J. H. FLETCHER & CO. Box 2187 – Huntington, WV 25722-2187 – 304/525-7811 – FAX 304/525-4025

INFORMATION BULLETIN NO. 107

| SUBJECT: | (C)HDDR OPERATOR DRILL STATION SAFETY ENHANCEMENTS |

CANOPY EXTENSION

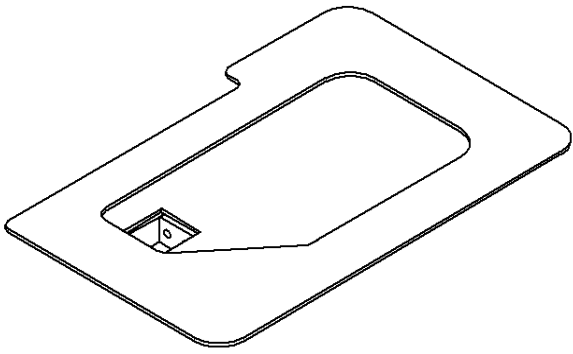
First: Fletcher has increased the size of the HDDR drill canopy (see Illustration 1). This new design adds up to 4" to the existing canopy inby towards the ATRS. The enlarged canopy provides additional coverage outby and towards the rib as well. Clearance

between the canopy and drill mast is reduced and must be evaluated to determine if this is a feasible option. Additionally, if your machine has an "L" style ATRS you may not be able to utilize this enlarged canopy.

ROCKER PAD ASSEMBLY

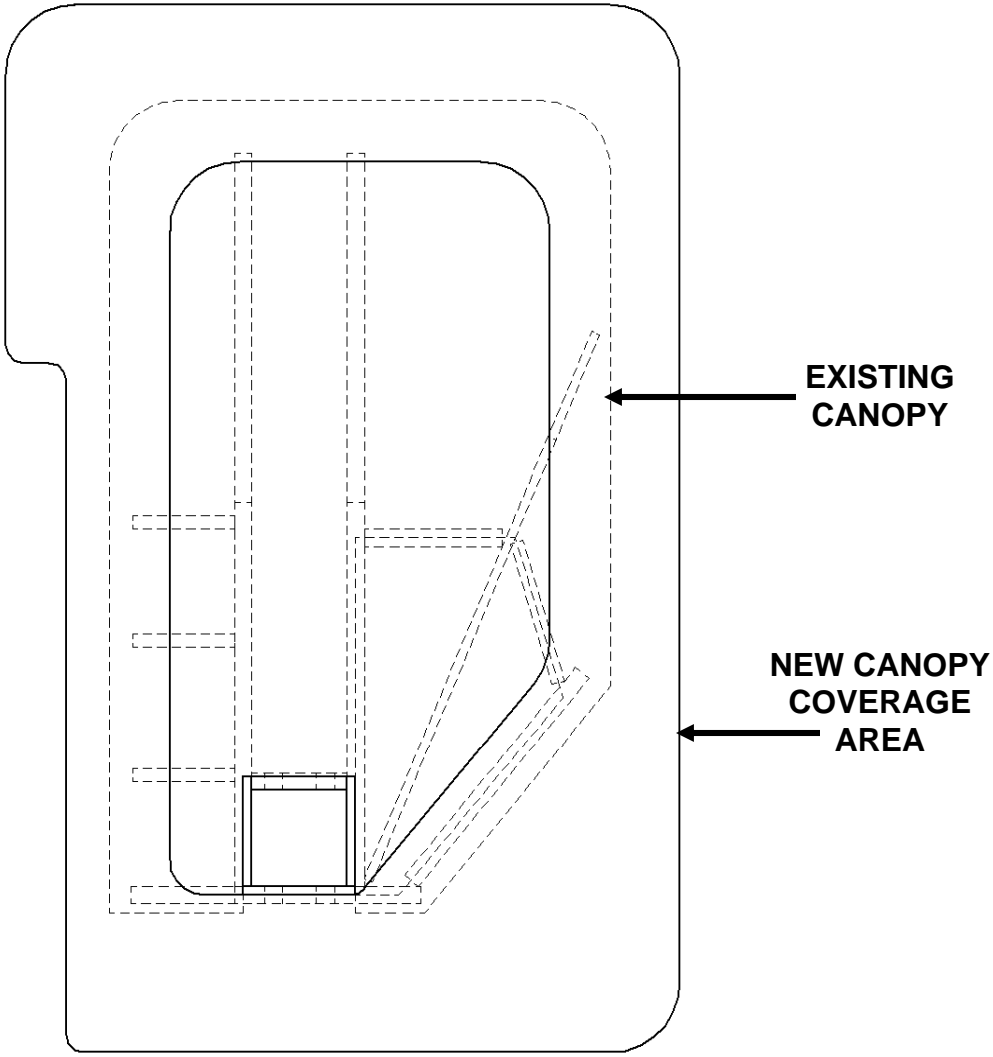
Second: Fletcher can provide a rocker pad with an outby extension for your TRS beam (see Illustration 2). The extension helps to reduce the gap between the outby edge of the ATRS rocker pad and the center of the drill head. The extension reduces clearance between the mast and ATRS. There is a risk that the extension could become fouled with other components or parts. Close attention and observation by the operator is essential when extensions are used. Damage to the mast or ATRS could occur.

RIB SHIELD

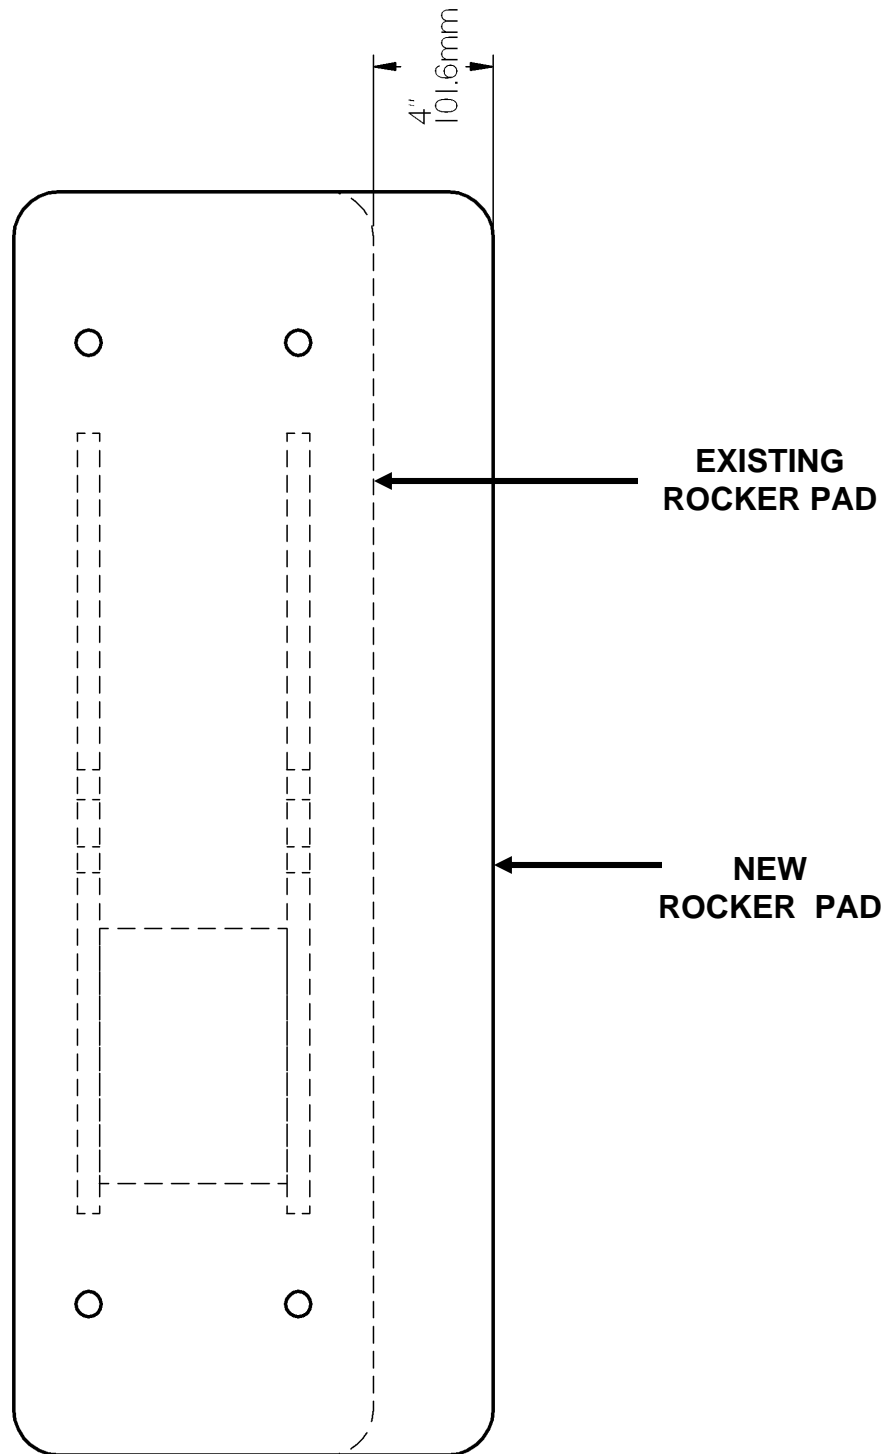
Third: Fletcher developed a rib shield for each drill boom operator (see Illustration 3). The rib shield attaches to the canopy to provide lateral protection from small rocks that might enter the drill control station. The addition of this component will reduce the collapsed height of the drill canopy.
